Draft Interim Review of PRM-50-93/95 Issues Related to the CORA Tests

Figure 1. Distribution of maximum heatup rates for CORA Tests when thermocouple temperatures are $T < 1200$ C.

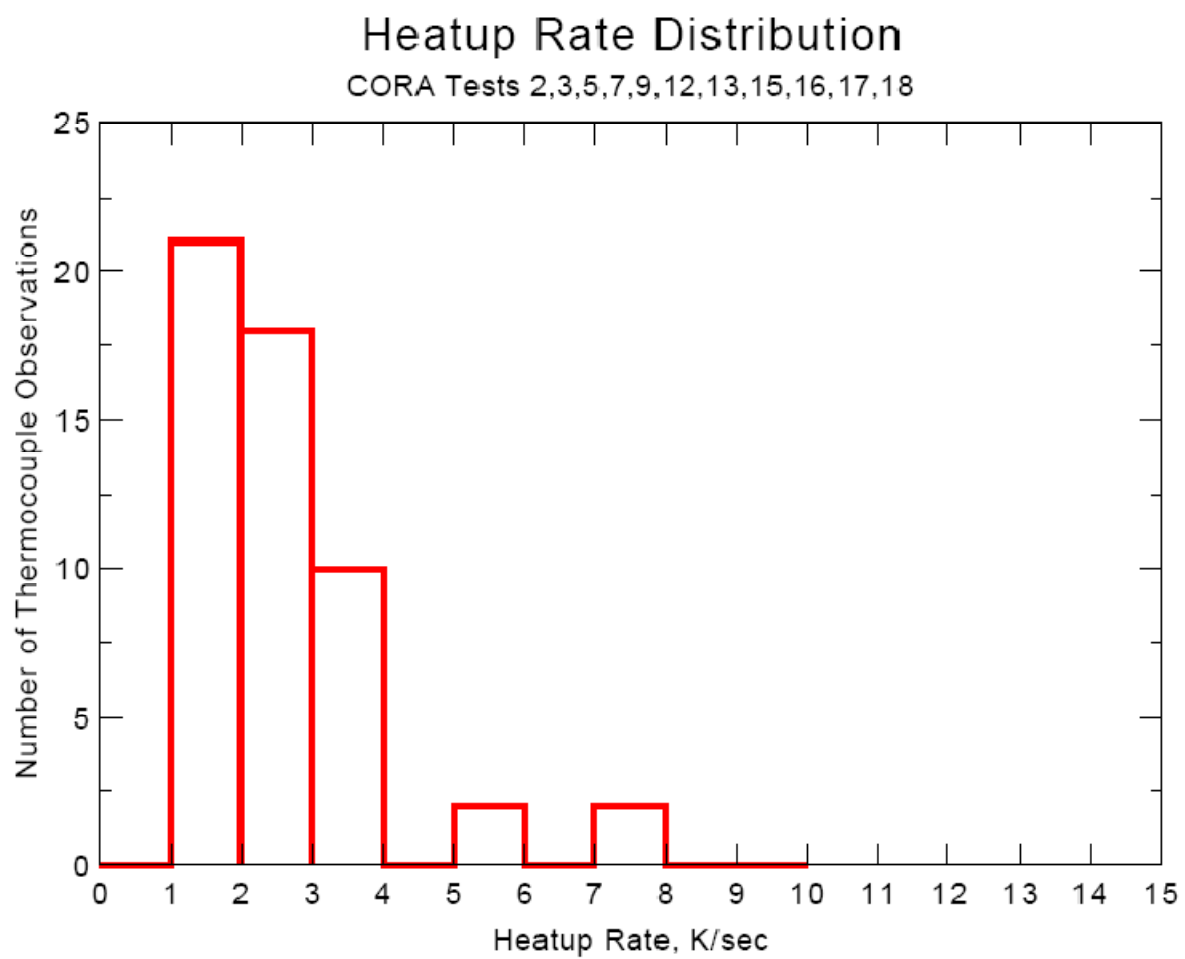
The petition is inaccurate in its characterization of the CORA tests. These tests were severe fuel damage tests, and conditions were designed to produce temperatures exceeding 2200 °F and relocation of parts of the fuel bundle. The data does show temperatures that increase at nearly 15 K/sec, however this rate of increase did not occur while temperatures were less than 2200 °F. As intended in the CORA tests, the heatup rate was initially about 1 K/sec. The rate of temperature increase did escalate as temperatures exceeded 1100 degrees Celsius (°C) (2012 °F). As temperatures approached 2200 °F, the rate of increase was generally 3 to 4 K/sec and only a few thermocouples had a more rapid heatup. Figure 1 shows a histogram of the thermocouple heatup rate distribution obtained by an evaluation of results from CORA Tests 2, 3, 5, 7, 9, 12, 13, 15, 16, 17, and 18. This includes all of the tests specifically mentioned in the

petition and related public comments. The median heatup rate of these thermocouples was approximately 2.25 K/sec, well below the 15 K/sec rate that is suggested as evidence of an autocatalytic reaction.

The distribution in Figure 1 identified only four locations in which the heatup rate exceeded 4 K/sec. While each of these locations had heatup rates well below that which might be considered autocatalytic, these apparent outliers received additional consideration. Each outlier was found to be located in the bottom half of the rod bundle. Figure 2 shows the heatup rate as a function of elevation in the bundle. The elevations of these outliers were 350 mm or less from the bottom. Two of these outliers occurred in Test 12 at 350 mm (7.5 K/sec) and at 250 mm (5.7 K/sec). However, when the heatup rates at these locations achieved their maximum (while the temperature was below 1200 °C), the upper part of the bundle had already started to melt and relocate. Figures 27 and 34 from the data report (Sepold et al., 2009a) show photographs from post-test examination of the bundle. Relocated material is clearly evident at the 350 mm and 250 mm elevations. While not specifically discussed in the data report (Sepold et al., 2009), these heatup rates occurred roughly 300 seconds later than when the absorber rods relocated. Thus, relocation of molten material and “candling” are likely causes of these isolated heatup rates. The measured hydrogen production rate in Test 12 during this period is also notable. At approximately 4300 seconds when elevations 350 and 250 mm achieved their maximum heatup rates while below 1200 °C, the hydrogen generation rate was increasing but leveled off by 4500 seconds. If an “autocatalytic” had actually occurred, then the hydrogen generation rate would have continued to increase.

The staff concludes that the behavior of temperatures in the CORA experiments is consistent with prior understanding and expectations on oxidation rate at temperatures below 2200 °F. No locations with temperatures less than 2200 °F with heatup rates greater than 10 K/sec were identified. The heatup rates below 2200 °F do not indicate a presence of an exothermic "autocatalytic" reaction. The results of CORA do not suggest that the Cathcart-Pawel or Baker-Just correlations are non-conservative. The assertions made by the petition with regards to Cathcart-Pawel and Baker-Just are not substantiated by the CORA data.

Figure 2. Maximum heatup rate in CORA tests with elevation.

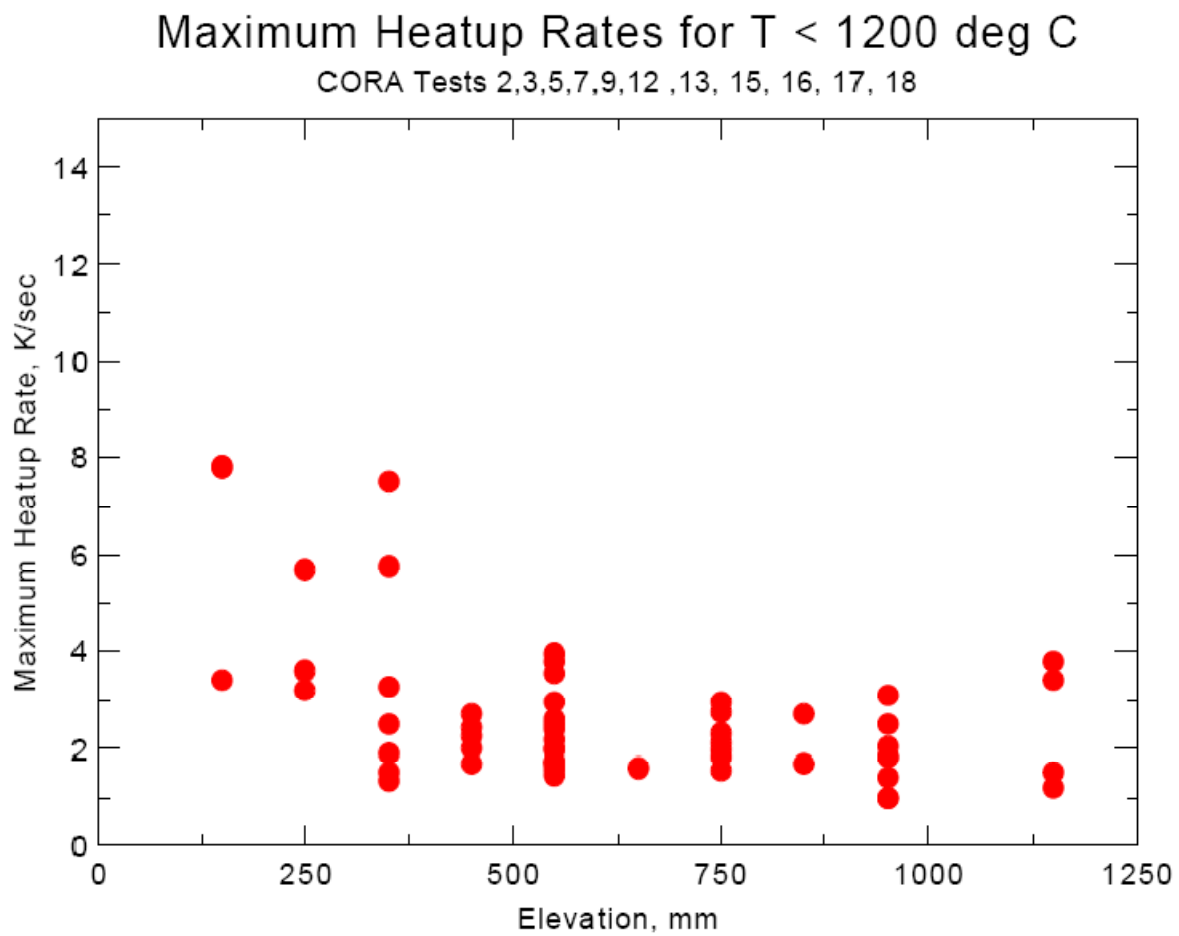
The other heatup rates that appeared to be outliers occurred in Test 16 (7.8 K/sec) at 150 mm and in Test 13 (5.8 K/sec) at 350 mm. The results from Test 16 are described by Sepold et al., 2009b and Test 13 by Firnhaber et al., 1993. As with Test 12, the maximum heatup rates at these elevations occurred several hundred seconds following the time at which melt and relocation was initiated in the upper part of the bundle. Post-test examinations confirmed the relocation of material to the lower parts of the bundle. The increased heatup rates are likely due to the relocation of molten material at these elevations. Again, as in Test 12, the hydrogen generation rates showed no signs of an autocatalytic reaction when the maximum heatup rates were observed. The hydrogen generation rates in Test 16 and 13 did not show evidence of an autocatalytic reaction at these times.
